RESPONSE TO REQUEST FOR ADDITIONAL INFORMATION

APR1400 Design Certification

Docket No. 52-046

RAI No.: 210-8239
SRP Section: 08.03.01 – AC Power Systems (Onsite)
Application Section: 8.3.1
Date of RAI Issue: 09/14/2015

Figure 1. Cable tray arrangement(section view) in cable tray tunnel

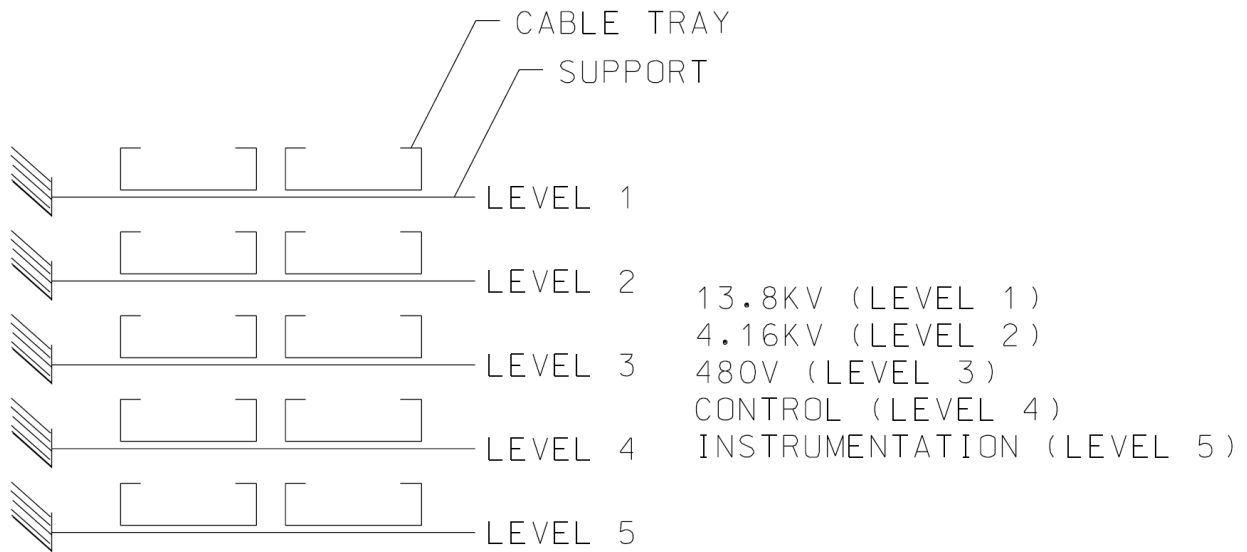
DCD Section 8.2.1.4 discusses the separation between the preferred power supply I and II. It discusses the cables that are routed from the SATs to the switchgears. The staff noted that the SAT LV side cables appear to be in a congested routing for connecting multiple secondary winding cables to the Class 1E and non-Class 1E switchgear. Please discuss how the APR1400 design addresses cable routing (through the trenches), cable spacing and separation, specifically when sharing safety-related cables of different voltage levels in raceways with non-safety-related cables, so that the design has capacity and capability to avoid unintended safety impact.

Cables from the SATs to the switchgears are routed in non-Class 1E cable trays through the cable tray tunnels, between SATs and building entries, and inside the turbine building or the auxiliary building.

Separate cable trays by voltage level (e.g., 13.8kV, 4.16kV, 480V, control, and instrumentation) are arranged typically in vertical direction with practical clearance between the cable trays. For each cable tray, appropriate cable spacing method is applied (e.g., maintained spacing for medium voltage cable trays and random fill spacing for low voltage, control and instrumentation cable trays). A typical layout (section view) of cable trays arrangement in the cable tray tunnel and a profile of maintained spacing of MV cables are provided in Attachment 1.
